**Fourth Addendum to the  
Transbay Terminal/Caltrain Downtown Extension/Redevelopment Project  
Final Environmental Impact Statement/Environmental Impact Report  
(SCH #95063004)**

**SUMMARY DESCRIPTION OF FOURTH ADDENDUM**

Figure 1, Revised Temporary Terminal Configuration and Off-site Traffic Circulation and Lane Configuration Plan

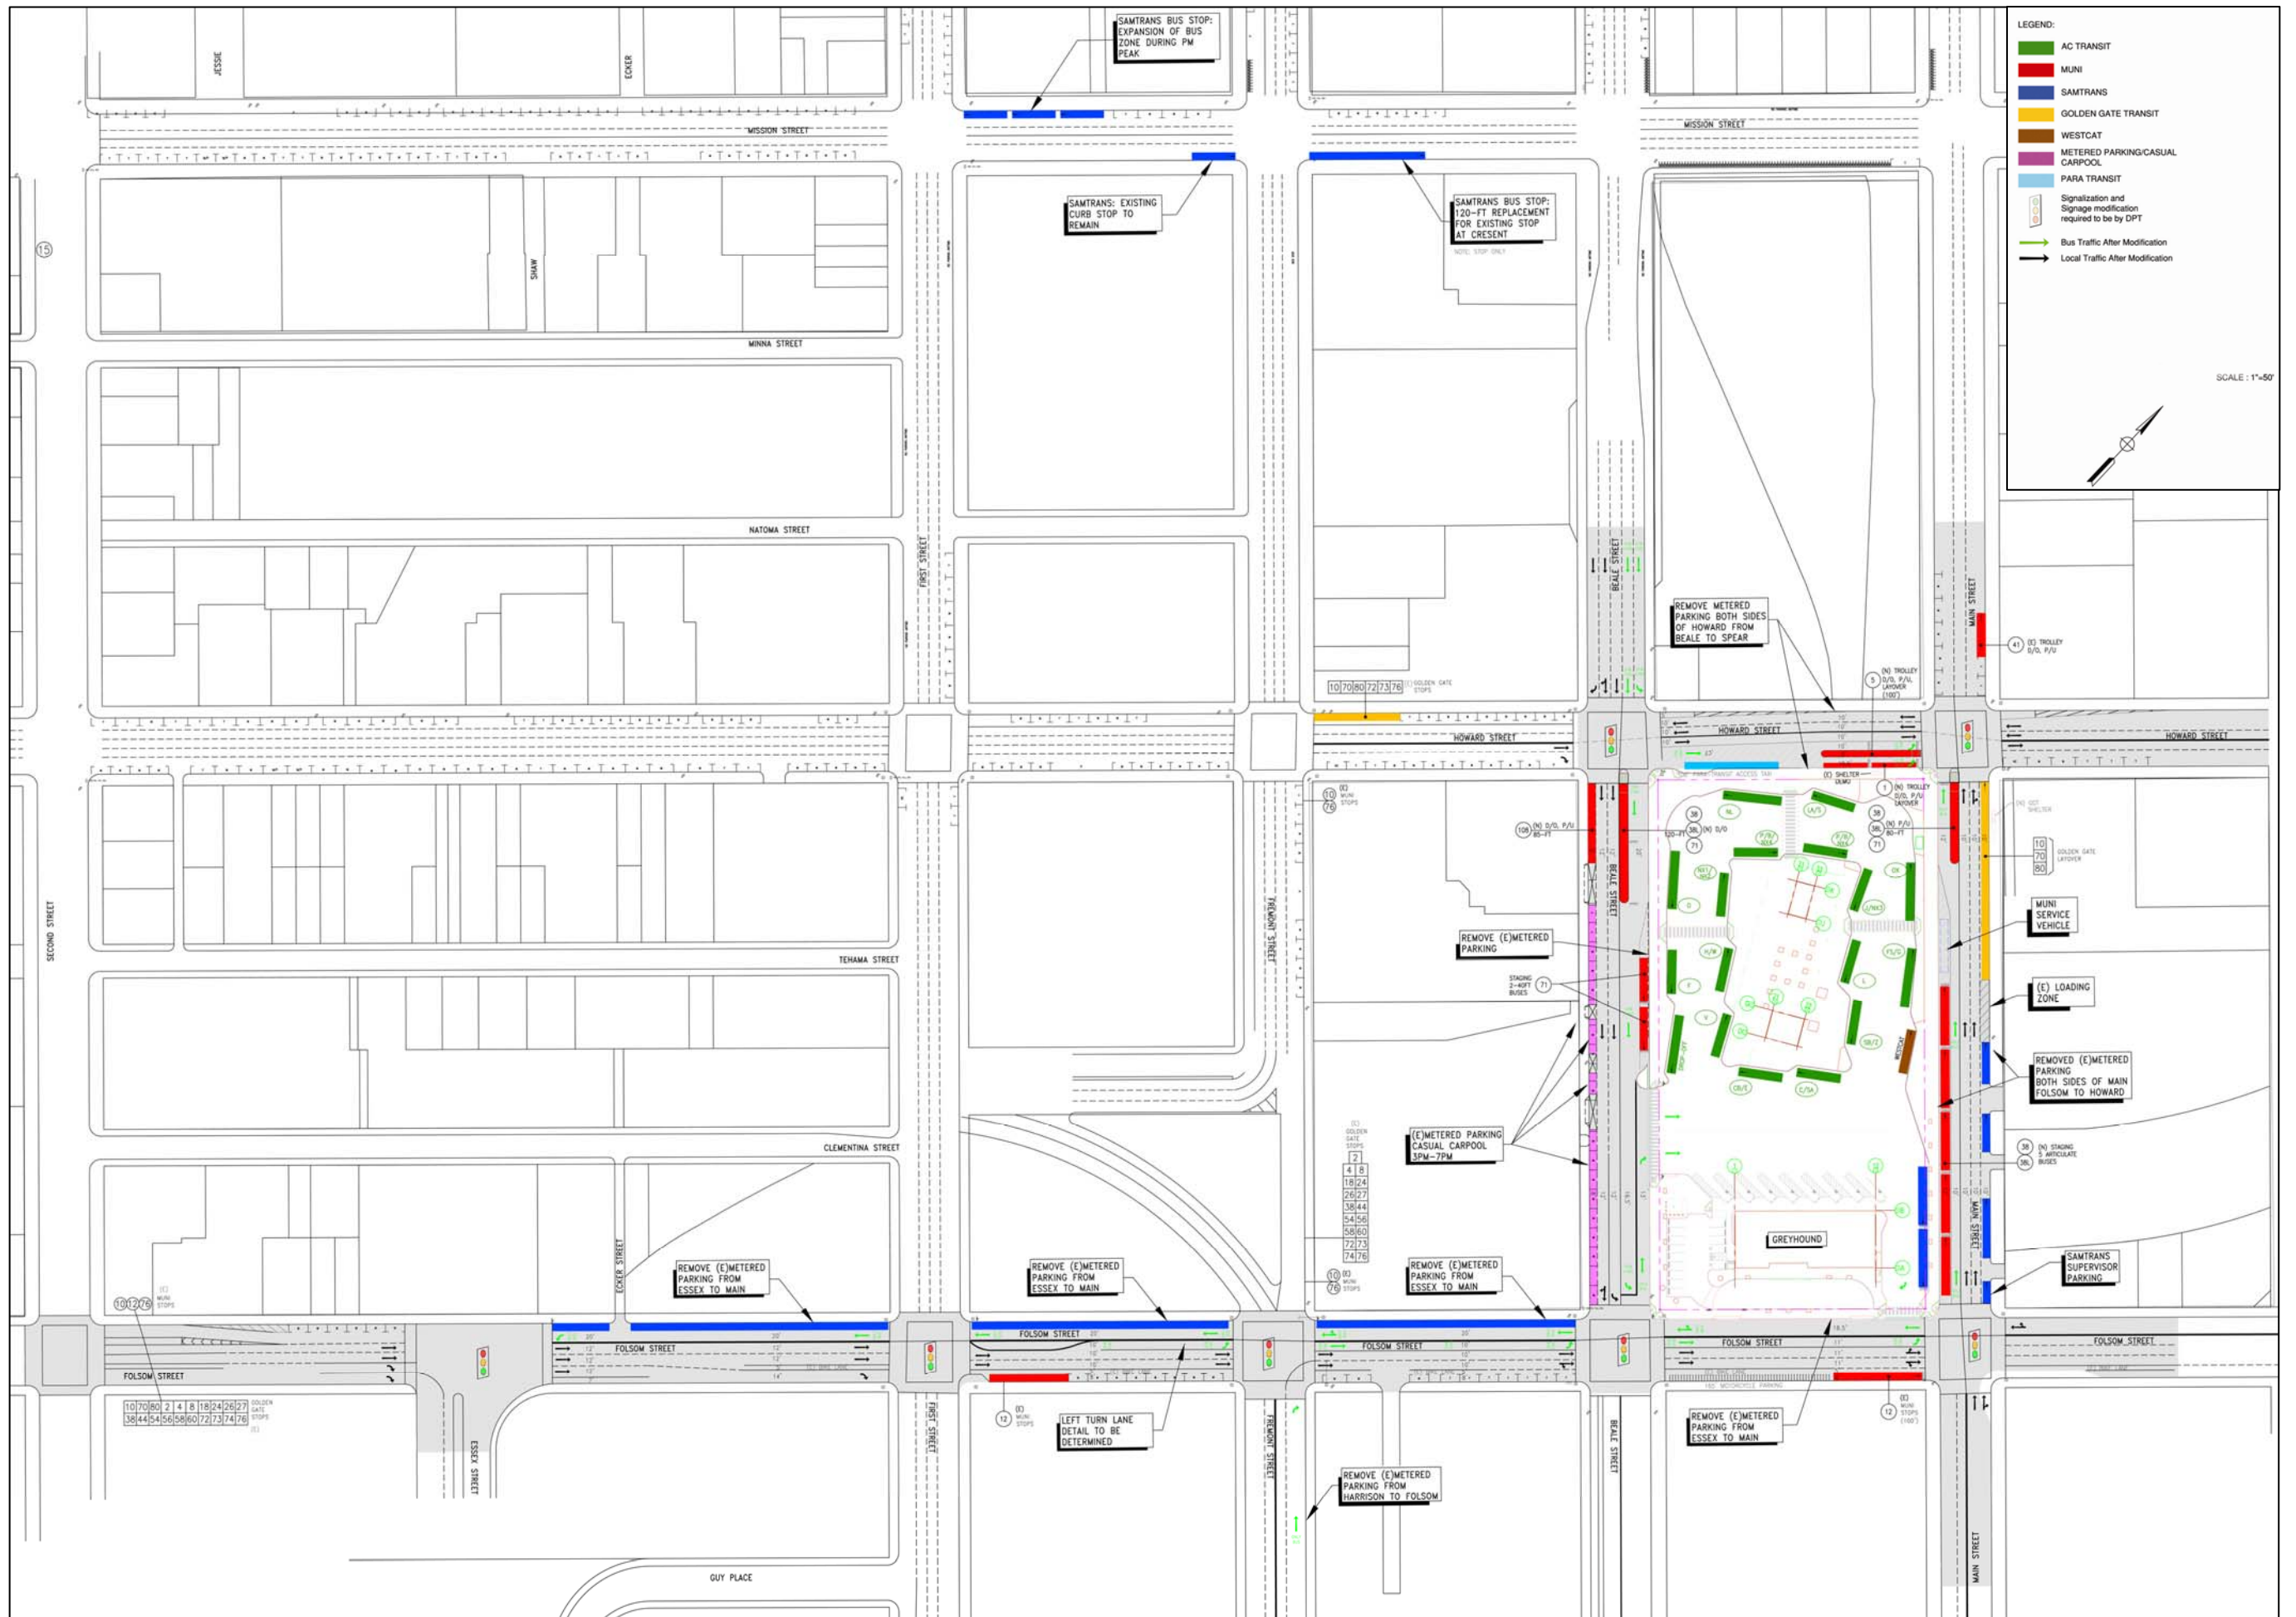
Although the purpose and function of the Temporary Terminal remains as stated in the FEIS/EIR, pursuant to the proposed project revisions, the configuration of the terminal, boarding platforms and waiting areas, bus staging areas, and street design has changed. Instead of being located on two adjacent blocks, the Revised Temporary Terminal will be confined to one block, bounded by Howard, Main, Folsom, and Beale streets. The Revised Temporary Terminal will contain AC Transit and Greyhound operations in separate operating areas and facilities (**Figure 1**).

The consolidated operation of buses onto one block requires the reconfiguration of the bus operating areas and circulation patterns described in the FEIS/EIR (pages 2-21 and 5-184). In the revised scenario, AC Transit uses a center boarding facility that contains a 1,030-square-foot office building and a 700-square-foot security office in a landscaped plaza in the northern portion of the block. The temporary structures, which would be demolished when the Temporary Terminal ceases operation, have shallow foundations and minimal (14-foot) heights. The AC Transit area contains 18 bus bays, 17 designated for AC Transit and 1 for WestCAT. The bus bays are sheltered by overhead canopies. Appropriate signage, ticketing kiosks, transit information, bike racks, restrooms, and waste receptacles accompany the boarding areas. Newly established utility lines that serve the bus facilities connect with existing lines along and under the surrounding streets. A two-way circulation area for buses surrounds the center boarding facility. Three specially designated walkways connect the perimeter of the block with the center boarding facility. As indicated in the FEIS/EIR, all pedestrian access and passenger facilities meet the requirements of the Americans with Disabilities Act. Landscaping is included at key points along the block perimeter.

The south end of the block bordering Folsom Street contains Greyhound operating facilities including an 8,550-square-foot office structure with ticketing, waiting area, restroom, baggage, and trash facilities. Similar to the AC Transit facilities, the temporary structure has a low elevation (16 feet) and shallow foundations, and is serviced by utility lines extending from the street right-of-way. Greyhound uses 8 bus bays sheltered by 28-foot canvas canopies. An exclusive 190-foot-long passenger pick-up and drop-off lane is located in front of the Greyhound building off Folsom Street.

Access to the AC Transit and Greyhound boarding areas is provided mid-block along Beale Street (refer to **Figure 1**). All buses exit on Folsom Street on the east end of the block adjacent to a staging area for SamTrans buses. SamTrans also has staging areas along the north side of Folsom Street between Beale and Essex streets; these staging areas are shared with the Caltrans bike shuttle.

Boarding areas on the curbside of the surrounding blocks have also been modified from those described in the FEIS/EIR (page 2-21). In the revised scenario, SamTrans and Golden Gate Transit have separate staging areas on the east side of Main Street (refer to **Figure 1**). They share a boarding area, including a passenger shelter on the sidewalk, along Main near Howard Street. Across the street, Muni has a staging area and a boarding island that separates two lanes of northbound traffic from a bus lane on the west side of the street. Additional stops for Golden Gate Transit are located on the north side of Howard Street at Fremont Street and for Muni along Howard Street in front of the Temporary Terminal. Muni is also allotted stops along the east side of Main Street north of Howard Street and the west side of Beale Street, and a boarding island on Beale Street just south of Howard Street. Muni shares the west side of Beale Street with carpool pick-up. Paratransit services are designated along the south curb on Howard Street.

The proposed project revisions would add bus lanes on Howard Street (eastbound direction) and would modify bus lanes on Beale Street to allow travel in both southbound and northbound directions between Howard and Folsom streets. Immediately north of Howard Street, Beale Street is redesigned to accommodate two bus lanes on the east side of the street and one lane on the west side with traffic confined to the two center lanes. The reconfigured bus lanes facilitate bus turning movements onto Howard and circulation into the bus lane on Beale Street south of Howard Street.

As indicated in the FEIS/EIR (page 2-23), buses coming off the Bay Bridge use the Harrison Street off-ramp to access the Temporary Terminal via Fremont Street, Folsom Street, and the bus lane on the east side of Beale Street. Fremont Street south of Folsom Street includes a PM peak tow-away lane on the east side of the street to allow AC Transit bus staging. Additionally, Folsom Street has a left turn pocket for Golden Gate and SamTrans bus movements onto Fremont Street. For outbound buses traveling between the Temporary Terminal and the Bay Bridge, buses depart the terminal on Folsom Street and use the Folsom Street westbound bus lane to reach Essex Street. Along Essex Street, buses continue in the southbound bus lane to reach the Bay Bridge on-ramp (refer to **Figure 1**). Bus lanes operating against the flow of traffic on these streets are in designated contra-flow lanes.

Additional modifications in the revised scenario include a PM peak bus staging area for AC Transit in one eastbound lane of Folsom Street between Fremont and Beale streets, and signal modifications along Folsom Street at First, Fremont, Beale, and Main streets and along Howard at Beale and Main streets to facilitate bus movement. **Table 1** compares the street and bus travel lane modifications for the Temporary Terminal described in the FEIS/EIR with those in the revised scenario.
